Re: XMBLY, Somerville, MA Draft Environmental Impact Report (EEA #15595)

July 20, 2018

Figure 1. Projected late-century coastal flooding (courtesy City of Cambridge)

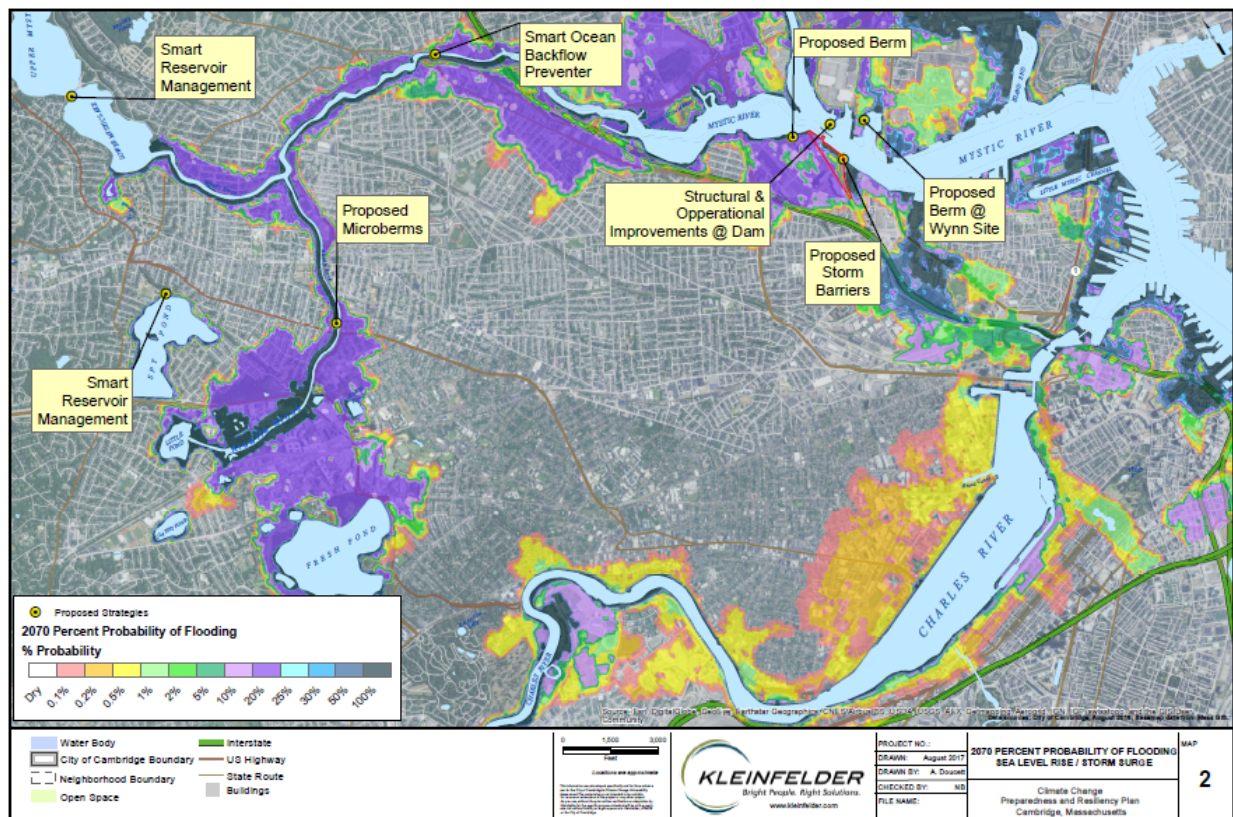
The XMBLY project is located outside the current FEMA 1% riparian flood zone as defined in 310 CMR 10.54(c) and is therefore currently presumed not to require protection from coastal flooding. This is not expected to remain true throughout the project lifespan, however. Kleinfelder's work for the Cambridge Climate Vulnerability Assessment indicates that Assembly Row is likely to flood at least twice each decade by late century (see Figure 1).

The developer proposes to raise finished floor elevations above projected flood elevations; this design should include the ability to continue to elevate the ground floor (e.g., through wet flood proofing and

including an extra-high first floor ceiling) as flooding becomes more chronic. In addition, critical building infrastructure should be elevated and waterproofed to allow for public safety during and rapid recovery following flood events. Each building should employ an updated flood hazard mitigation plan to protect occupant and public safety.
